SAFETY RECALL NOTICE

VOLVO CAR USA LLC
PO Box 3757, Highland Park, MI 48203-9984

IMPORTANT SAFETY RECALL INFORMATION

NHTSA RECALL 19V849

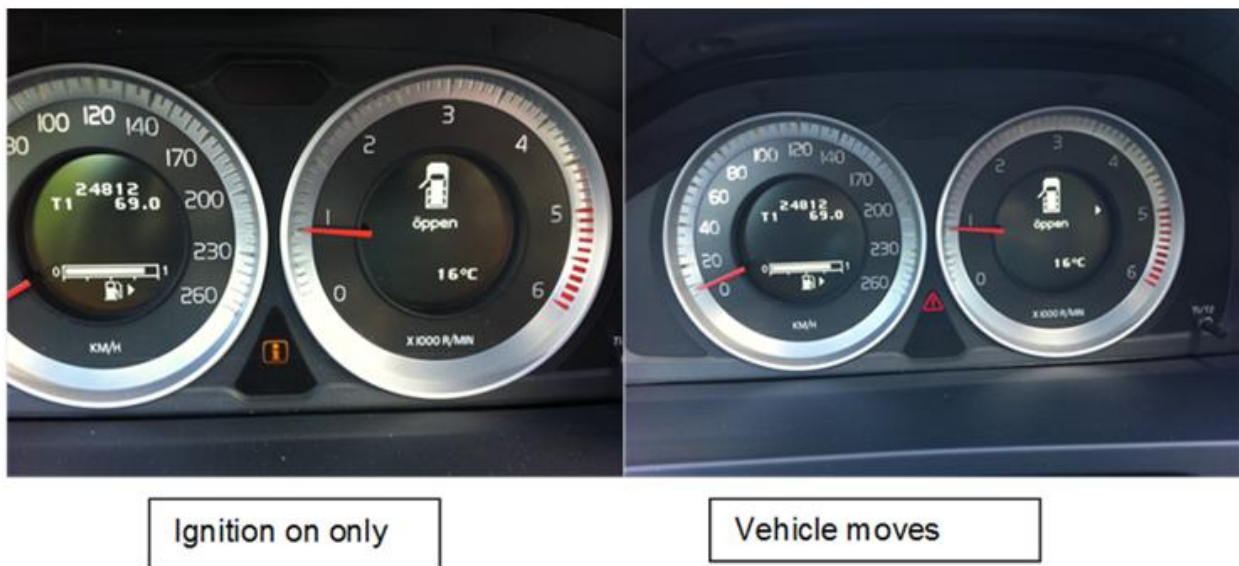
Volvo has identified that vehicle exposure to hot climate conditions over time, can cause the door latch to weaken and the retention hook for pawl spring in the side door latch to break. This can make the doors difficult to latch, or lead the driver/passenger to believe the door is securely closed when it is not.

A door that is not securely latched could open while the vehicle is in motion, increasing the risk of injury to a vehicle occupant.

The corrective action is to replace all four (4) door latches in both front and rear side doors with new improved door latches, free of charge.
